GOVERNMENT OF THE DISTRICT OF COLUMBIA
DEPARTMENT OF TRANSPORTATION

MEMORANDUM

SUBJECT: BZA Case No. 19250 – 920-922 H Street NE

Figure 1. Proposed First Floor Site Plan (Source: Applicant)

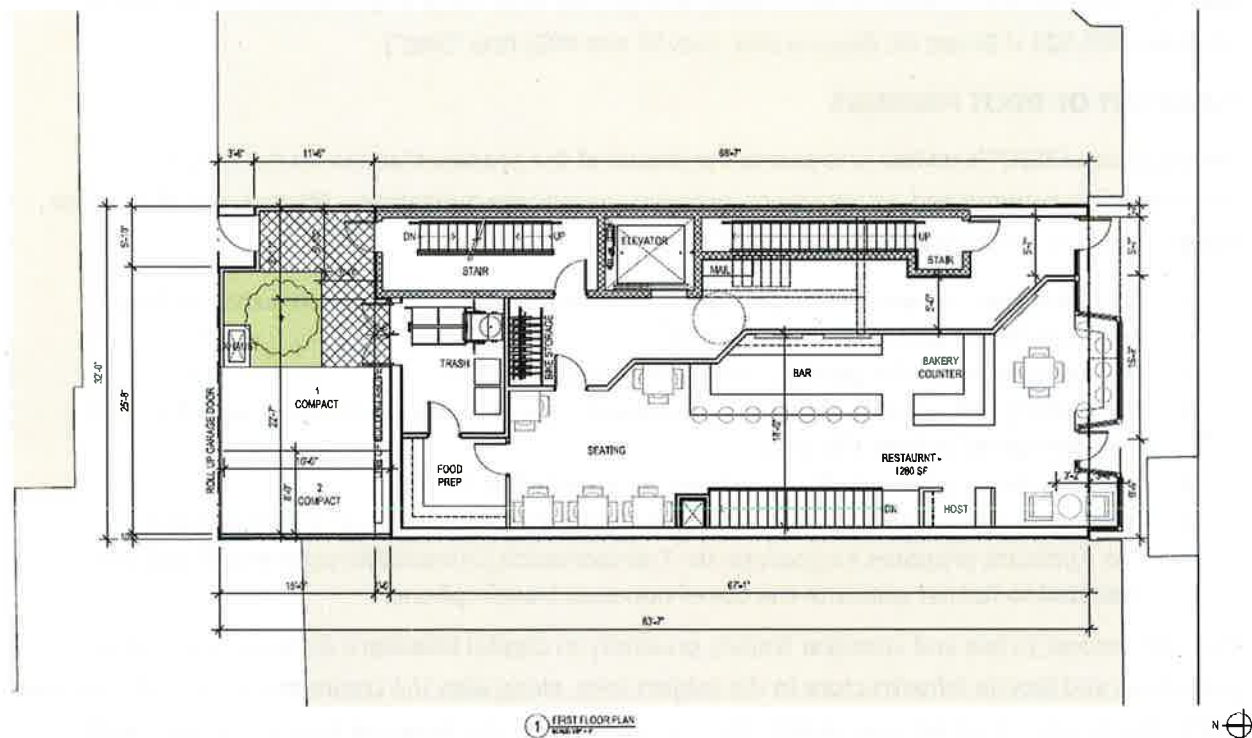
The proposed building is providing two vehicular parking spaces, however is required by zoning regulation to provide ten for the residential and retail uses.

Generally, DDOT has no objection to reduced parking provision if documentation as to where parking could occur is made and if the overall available transportation network supports an appropriate split between vehicular, transit, pedestrian, and bicycle trips. Thus, DDOT finds appropriate the lack of parking provision in this area due to the close proximity to transit, provided bicycle storage, nearby available parking, and the overall relatively minor increase in vehicular trips. Further, the Applicant has proposed appropriate TDM measures, which will further alleviate parking needs. DDOT does not object to these spaces being compact.

DDOT's practice is to accommodate vehicle loading in a safe and efficient manner, while at the same time preserving safety across non-vehicle mode areas and limiting any hindrance to traffic operations. For new developments, DDOT standards require that loading take place in private space and that no back-up maneuvers occur in the public realm. This often results in loading being accessed through an alley network or an approved loading location. Here, however, the Site does not propose loading space off the alley.

Zoning regulations do not have a loading requirement for this development, and so loading is not part of this zoning action. However, a workable loading concept is necessary to show this building can be later permitted as part of the public space permitting process. While H Street has a parking lane, streetcar service at this location does not allow for loading activities to occur as the parking lane is too narrow to allow truck parking without interference with streetcar operations.

The Applicant anticipates using an existing loading zone on 9th Street. While this plan will accommodate most of the loading anticipated, it will require trucks to move through the neighborhood to access this location and retail deliveries will require goods movement along the sidewalks between the loading zone and the retail entrances. These loading operations are not optimal, but are acceptable considering the constraints caused by the streetcar, and it is anticipated that trash collection will occur in the rear alley.

DDOT expects the Applicant to comply with DDOT's standards for loading, the details of which will be addressed further, as necessary, as part of the permitting process for this property.
